ADDENDUM #1

HIGHLAND 1,000,000 GALLON ELEVATED WATER STORAGE TANK

City of Duluth, Minnesota

**ADDENDUM #1
HIGHLAND 1,000,000 GALLON ELEVATED WATER STORAGE TANK
CITY OF DULUTH
PROJECT 0768WA
BID NUMBER 10-0314
JUNE 17, 2010**

WATERMAIN LOWERING DETAIL

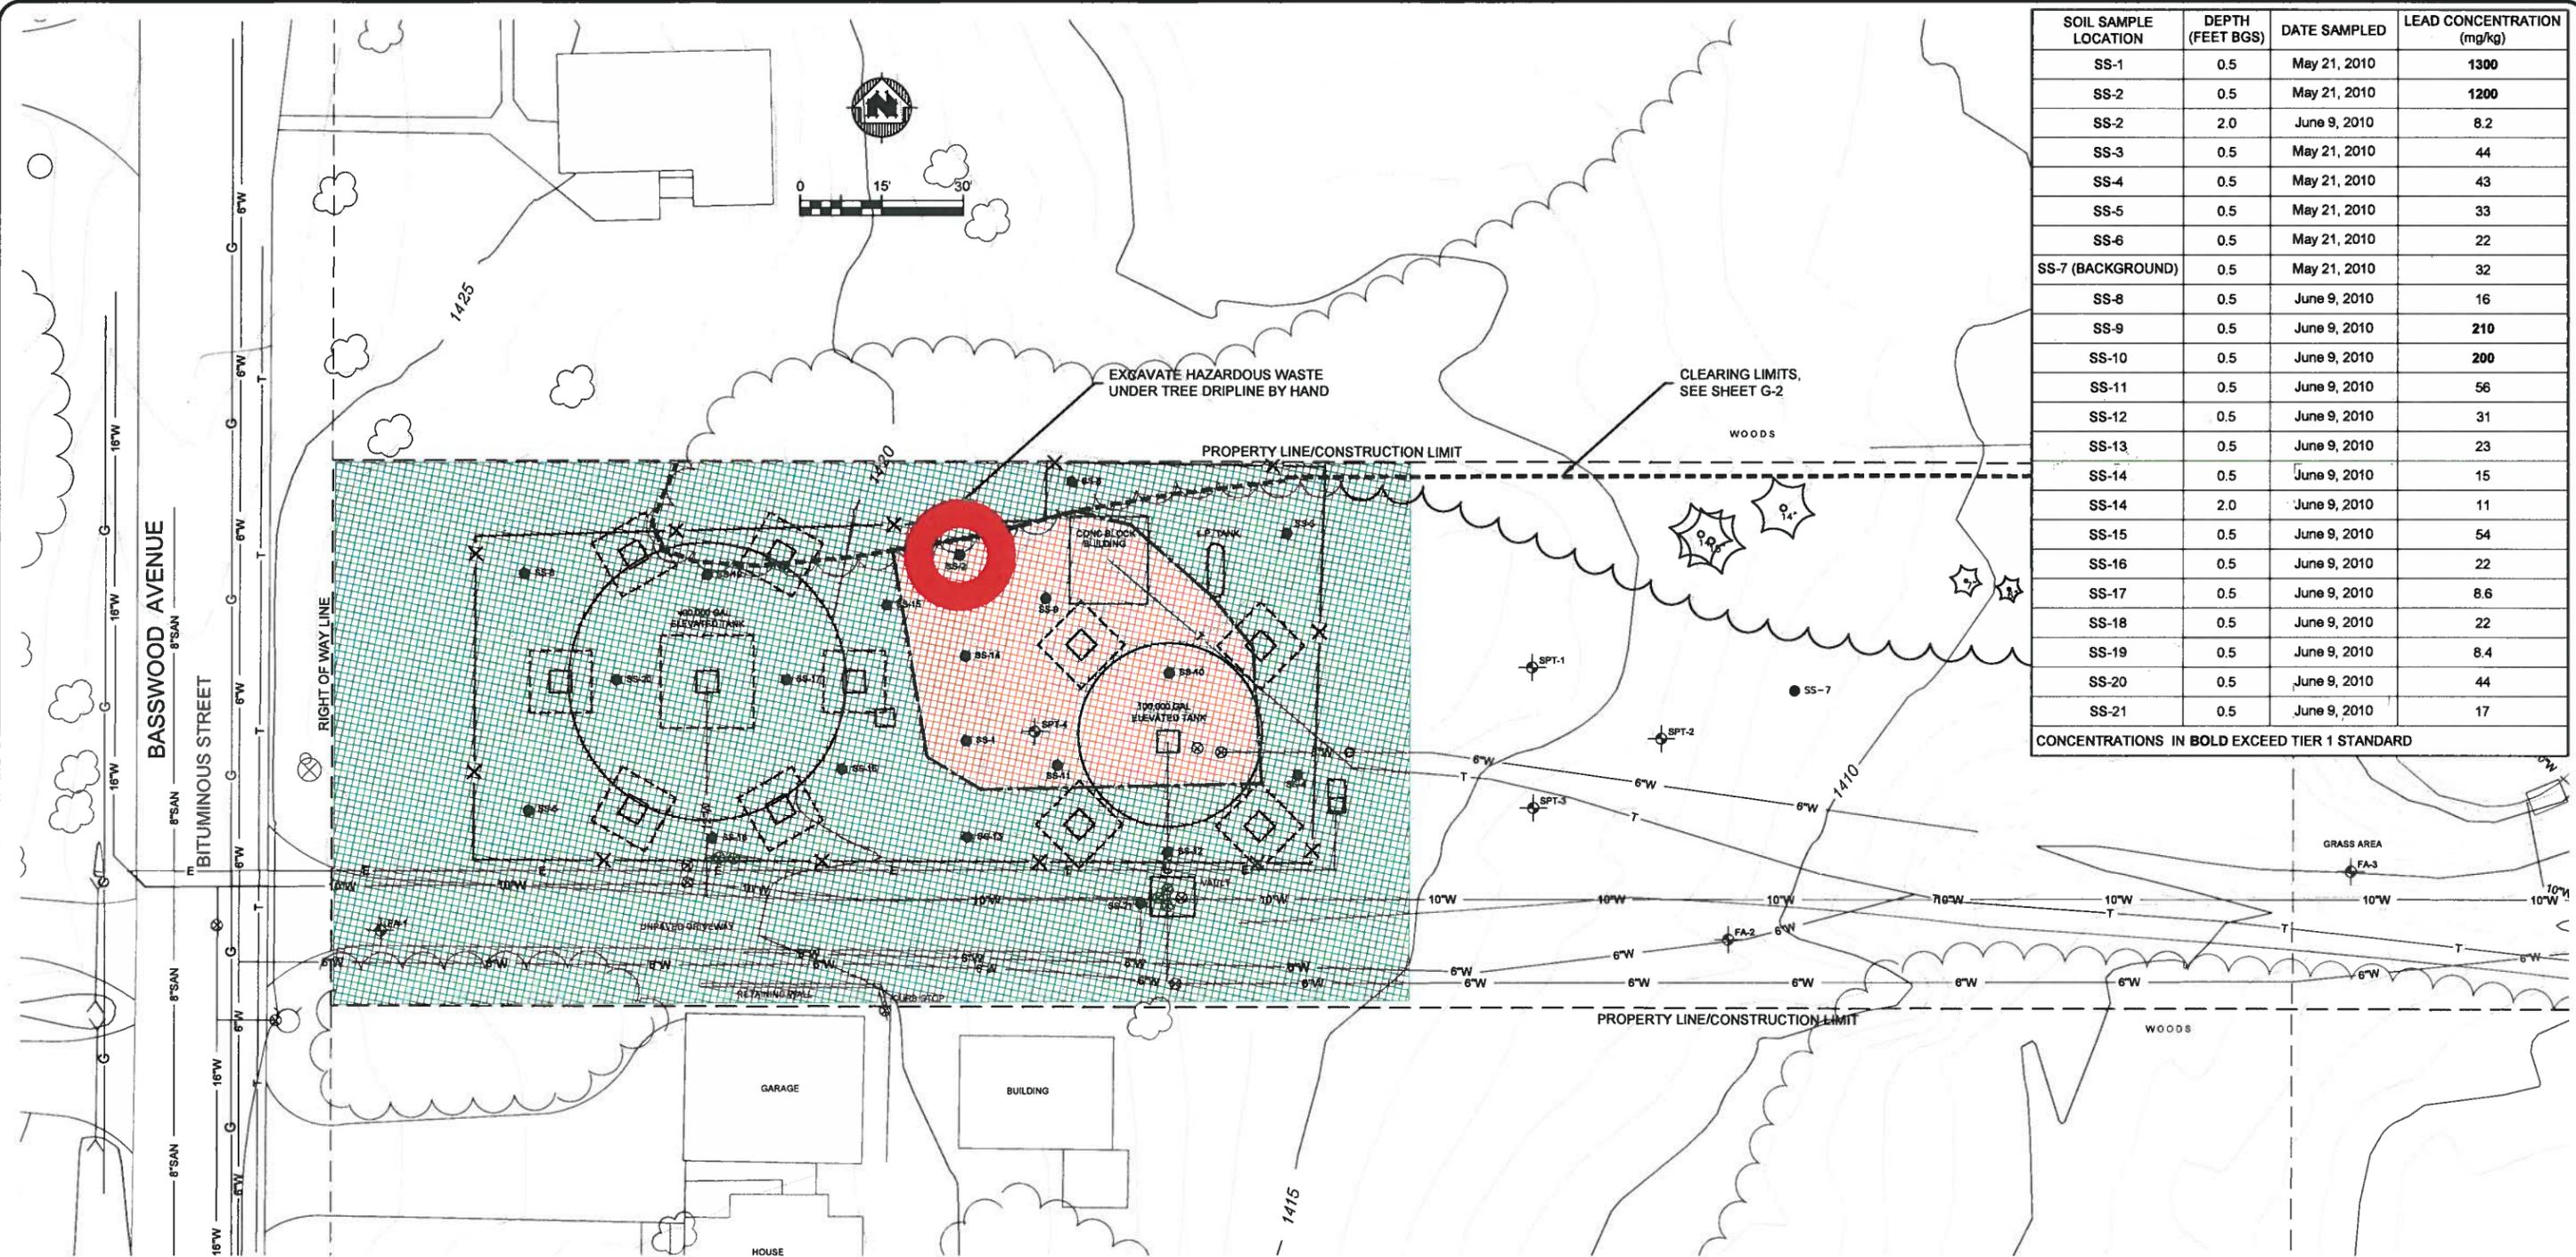
ADD attached Water Main Lowering Detail.

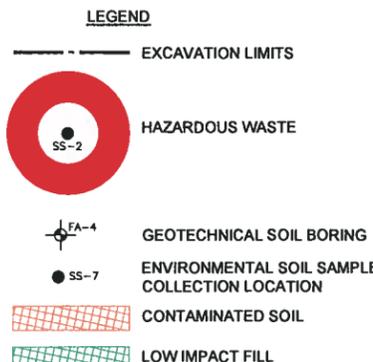
ADD the attached Drawing G-10 Environmental Soils Information.
